THE REVISED SITE LAYOUT (for BM2/4) JUST SUBMITTED BY AVANT (formerly Alfa) HOMES

SHOCKING REVISED LAYOUT

How to object: Case No: 20/05181/FULMAJ
Write to Kate Broadbank, Harrogate Borough Council,
PO Box 787, Harrogate, HG1 9RW or
Email: planningplanningcomments@harrogate.gov.uk
The village website, Bishop Monkton Today, has further details.

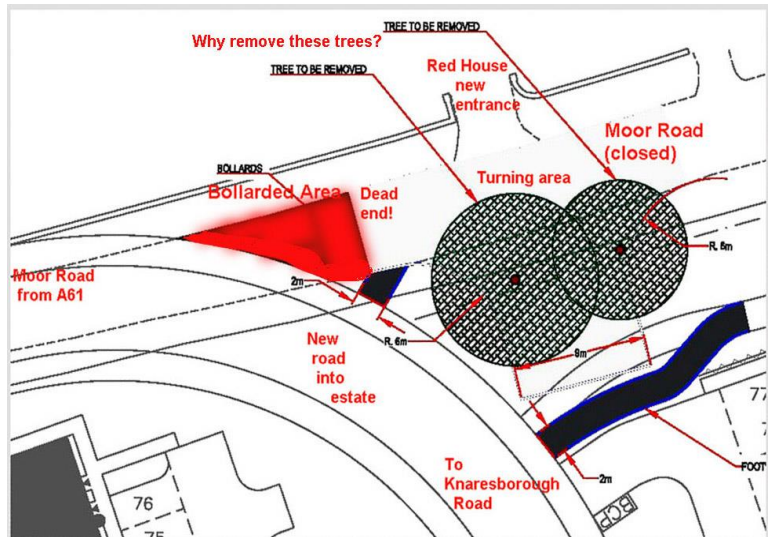
Moor Road entrance to the Village to be CLOSED!

The end of Moor Road would be cut off, leaving just a 'stub', only accessed from the X-roads.

All traffic routed through a dense housing estate, with people, children, bikes, dogs, parking – daft!

What about safety and pollution?

An Unimaginative Scheme, limited house designs, few garages (18) or with front gardens (hard standing car parking) and little internal greenery.

88 new houses, totally out of place in our village

This revised plan from Avant Homes includes a marginal reduction in houses from 98 and some overall movement of buildings away from the Old Vicarage but, on balance, little else. **There is much that is impractical and unacceptable.**

It closes the principal route into the village creating a diversion through a badly designed dense and ugly housing estate with parking areas and the smaller most 'boring' houses being faced first (the larger ones being in the extremities of the site).

The proposed road layout presents fearsome and extra safety issues - there are much better ways of reducing danger at the X-roads. Unacceptably, the site design contravenes National Planning Policy Framework (NPPF 126) and HBC's own Local Planning Policy by ignoring "At settlement edges, new development should harmonise with the wider landscape to aid transition from the built form to the adjoining countryside." These requirements are re-emphasised in HBC's "Bishop Monkton Conservation Area Character Appraisal" (1.8 and 5.8).

A **Pedestrian Crossing** is shown on the Knaresborough Road – nothing about what type but clearly it's in the wrong place.

A Cul-de-sac, created by the bollards - it looks ripe for **fly tipping**

A huge Attenuation Tank (to 'collect/buffer' the surface water) and a Pumping Station would occupy part of the SE corner. We have big concerns about the **removal of 'foul water'** from the site and the **'surface water'** (mainly from the Attenuation Tank).
